Work Order ID 122989

Item Name: Channel

APICAL INDUSTRIES, INC.	ENGINEERING CHANGE NOTICE NO. 03698				SHEET 1 OF 1	
	DWG NO. 647.0300	REV: N/C	PREPARED BY B. PETERS	DATE: 11/14/12	EFFECT ON DWG <input type="checkbox"/> INC. <input checked="" type="checkbox"/> UNINC.	
	DWG TITLE: CHANNEL					
APPROVED BY: ENGR <i>[Signature]</i>		MFG <i>[Signature]</i>	QC <i>[Signature]</i>	EFF: NEXT ORDER		
TRANSACTION CODES (TC) A-ADD C-CREATE R-REVISE D-DELETE		REASON: ADDED ALTERNATE MATERIAL.			ECR: D-12-016

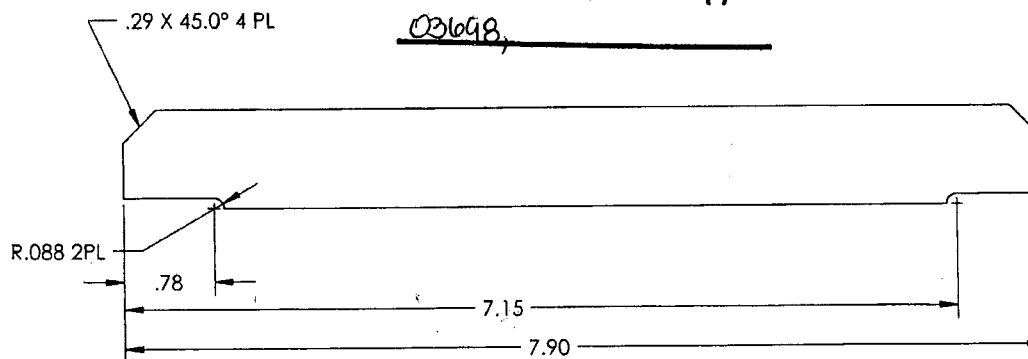
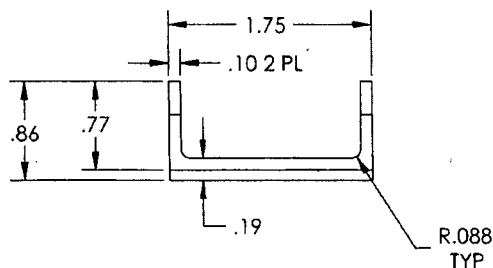
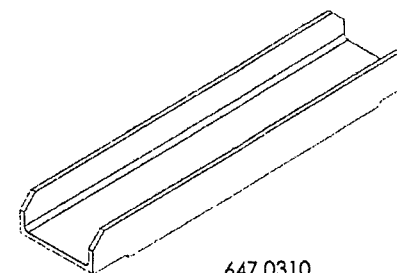
SHEET 1, ZONE A2 IS:

1 MATERIAL: 7075-T6 ALUMINUM PER AMS-QQ-A-225/9
ALTERNATE: 7075-T6511 ALUMINUM PER AMS-QQ-200/11
